DEPARTMENT OF TRANSPORTATION

National Highway Traffic Safety Administration

Federal Motor Vehicle Safety Standards; Child Restraint Anchorage Systems; Child Restraint Systems

ACTION: Notice of proposed rulemaking; response to petitions for reconsideration, technical corrections.

Figure 2. Corrected Placement of Symbol on the Seat Back and Seat

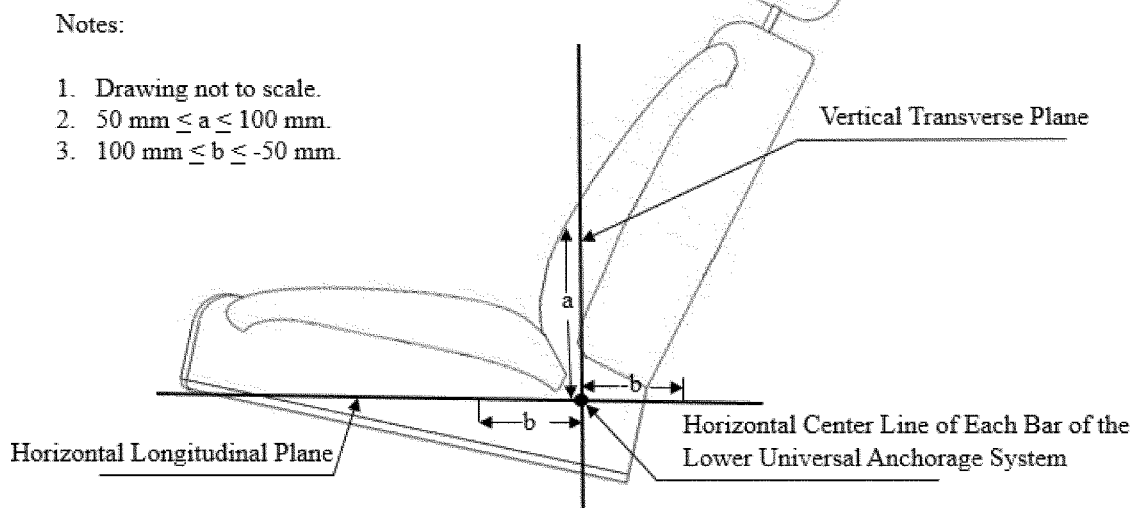
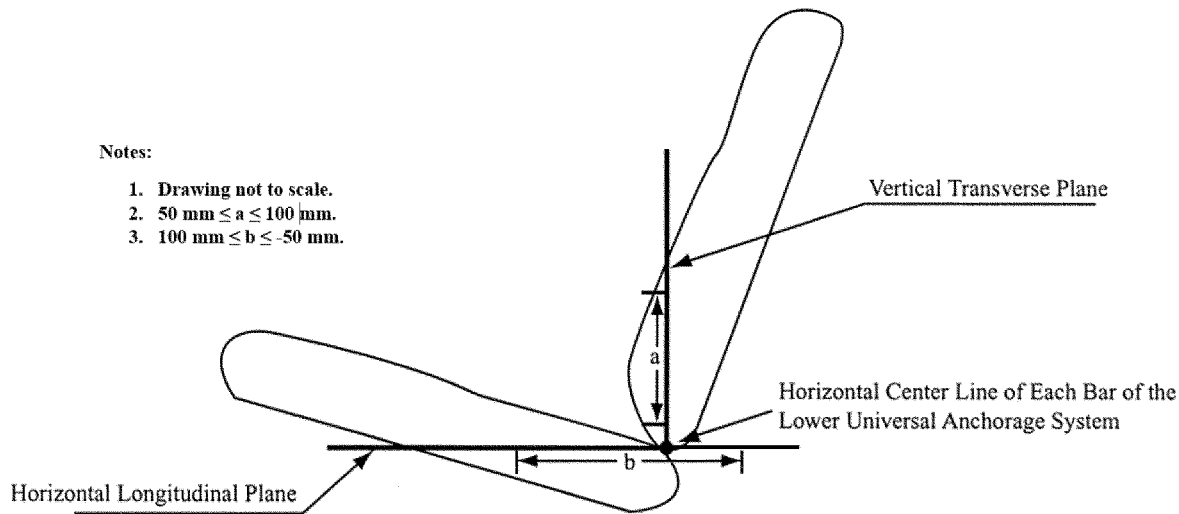
Mercedes-Benz requested that NHTSA extend the permissible Vertical Transverse Plane (the “a” measurement in Figure 19 of the standard, reproduced

in Figure 1 below) to locate the lower anchorage marking symbol on the seat back of the vehicle from the specified 50 to 100 mm range to a range from negative 50 to 100 mm. Mercedes-Benz stated that this change would allow the markings to be located on the molded anchorage rod fixture while still being easily visible to CRS installers.²¹

NHTSA is denying Mercedes' request as unnecessary. In the June 27, 2003 final rule that is the source of the current requirements in S9.5.1,²² the agency changed the original requirement, which consisted of only a vertical placement distance for the marking (seat back), to one that also allowed a horizontal placement for the marking on the seat pan. The 2003 final rule implemented this change in response to comments from Mitsubishi and the Alliance, who asked where the “seat back” begins for the purpose of marking the lower anchorages on highly contoured seats. Specifically, Mitsubishi stated that the bottom cushion of some of its seats curves toward the vertical

In light of the request from Mercedes, NHTSA proposes to modify the regulatory text for both the current requirements (S9.5.1(a)(3)) and the

updated requirements (S9.5.2(a)(3)) to clarify the permissible marking locations. NHTSA is also proposing to amend Figure 19 to FMVSS No. 225 so that the "b" measurement is specified as a continuous interval (Figure 2) instead of broken into positive and negative segments (Figure 1).

Figure 3. Anchorage Depth Angle Set Up

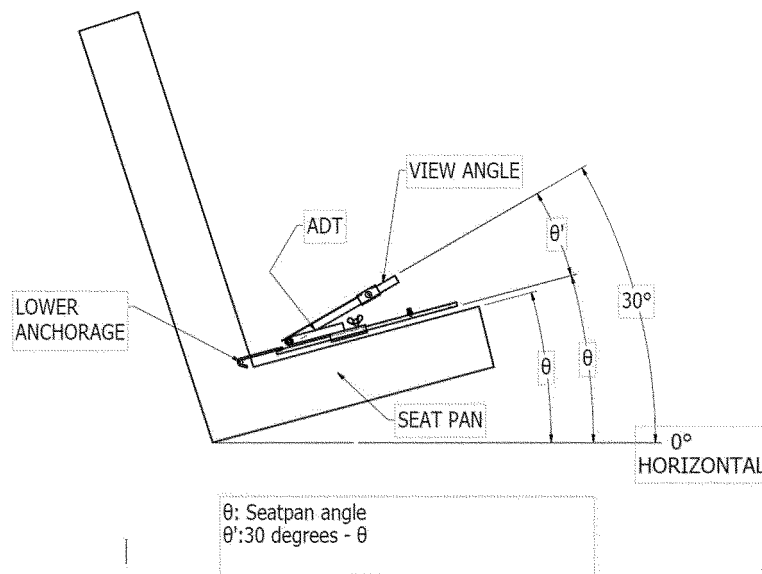
Paragraph S11(c) of FMVSS No. 225 describes the test procedure to measure the anchorage depth with the depth tool. However, this section lacks clarity on determining the view angles and positioning of the depth tool on the seat pan (see Figure 3). The research test procedure docketed²⁹ along with the 2025 final rule details the procedure with the desired clarity. Accordingly, NHTSA proposes to amend S11(c) of FMVSS No. 225 to align with this research test procedure.

(c) *Anchorage depth.* The seat back angle, if adjustable, is set at the manufacturer's nominal design seat back angle. If the position is not specified, set the seat back at the first detent rearward of 25° from the vertical. To measure the anchorage depth, the tool view angle is determined by subtracting the measured seat pan angle from 30 degrees. With the anchorage depth tool (see figure 28 to this section) on a flat surface, adjust the view bar to read the view angle. Slide the zeroing strip along the view bar so that it is barely touching the top of the depth tool hook. Move the view bar forward, so the end of the zeroing strip is aligned with

Figure 19 to § 571.225. Placement of Symbol on the Seat Back and Seat Cushion of Vehicle

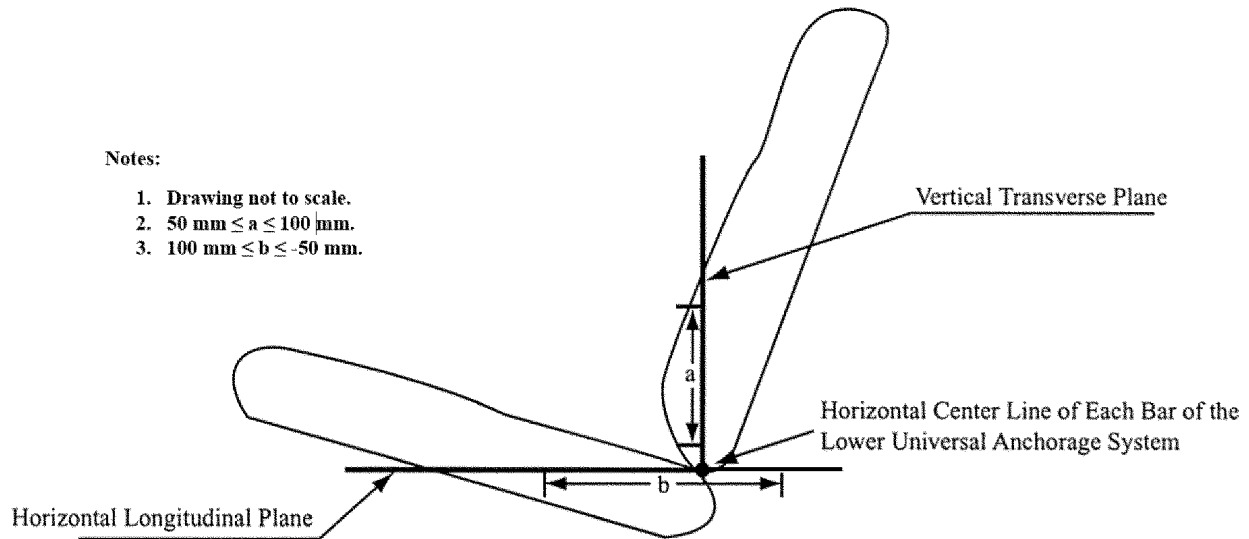
■ i. Revising Figure 19.

(4) That is located such that its center is (as illustrated in figure 19 to this section):

(i) on the seat back between 50 and 100 mm above the horizontal longitudinal plane that intersects the horizontal centerline of the bar; or

(ii) on the seat cushion between 100 mm forward of, and 50 mm rearward of, the vertical transverse plane that intersects the horizontal centerline of the bar.
